**MARION TOWNSHIP PLANNING COMMISSION
AGENDA**

RE: 1382 Lucy Road
Preliminary Site Plan Review

**Preliminary Site Plan Review
For
Marion Township, Michigan**

Applicant: Vern Brockway
Project Name: 1388 Lucy Road
Plan Date: September 25, 2020
Location: Lucy Road (Approximately .99 acres)
Zoning: LI: Light Industrial
Action Requested: Site Plan Approval
Required Information: Noted in Review

Figure 1 – Aerial Image of Site and Surroundings

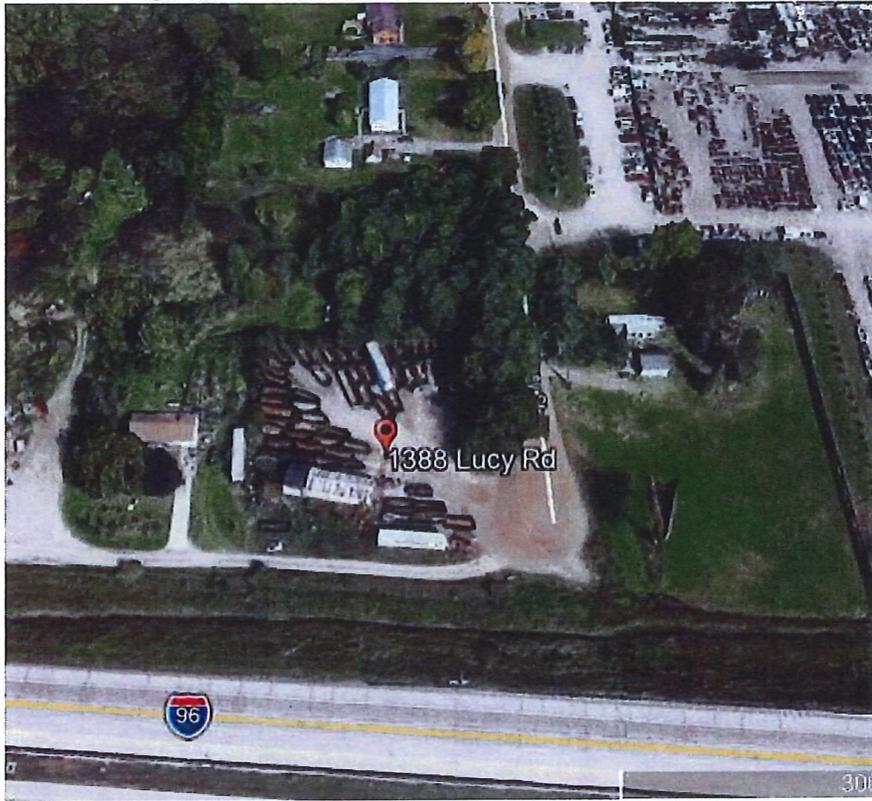
Significant natural features are shown on the plan and the aerial photo indicates mature trees on the northern boundary. These are shown on the provided preliminary plan and they are proposed to be removed.

Figure 1 – Aerial Image of Site and Surroundings

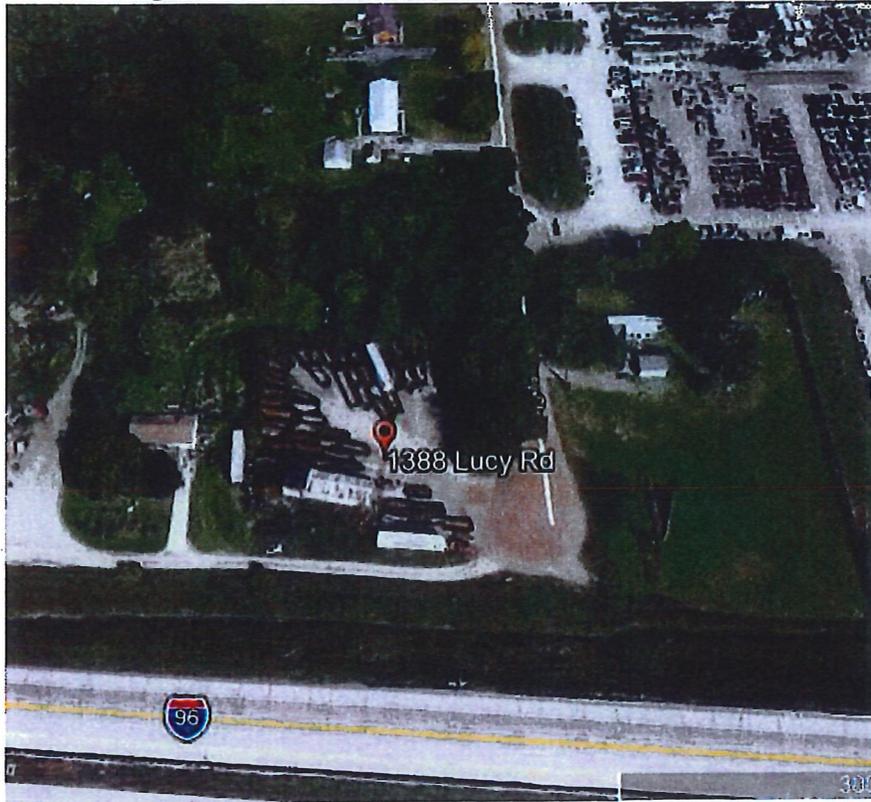
No significant natural features are shown on the plan; however, the aerial photo indicates mature trees on the northern boundary. These are shown on the provided preliminary plan.

Items to be addressed: Clarify any preservation of existing vegetation.

RETENTION BASIN PLAN & PROFILE

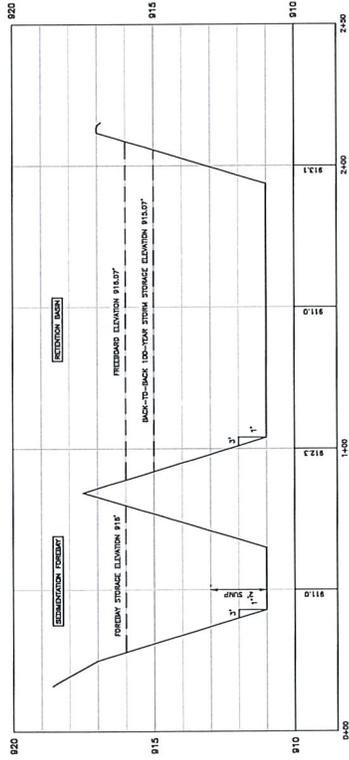
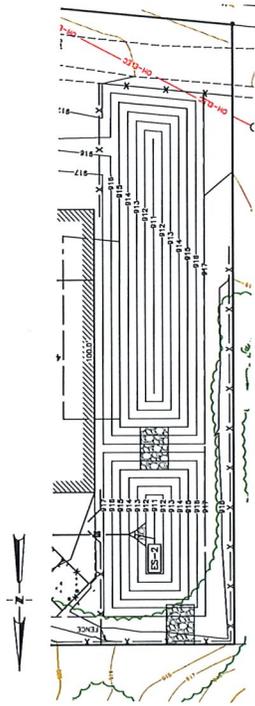
A retention pond is proposed on the west side of the site with a sediment forebay on the northwest corner of the site. There are no inlets or outlets shown on the plans. The site should drain entirely to the retention basin either by overland sheet flow, swales, or storm sewer. Calculations were provided for a detention pond, but not a retention pond. The storage volume of the retention pond must be capable of storing two inches of runoff from the entire tributary area. The slope of the retention pond is 1:3, which will require the retention pond to be fenced off at all sides. We defer to Livingston County Drain Commissioner for further comment on the design of the retention basin.

4. Correct the legal description.
5. Plans need a professional seal.
6. Vicinity map needs a scale.
7. Details on the proposed barn should be provided.
8. Grading plan should be added to the plans.
9. Calculate for retention pond and not a detention pond.
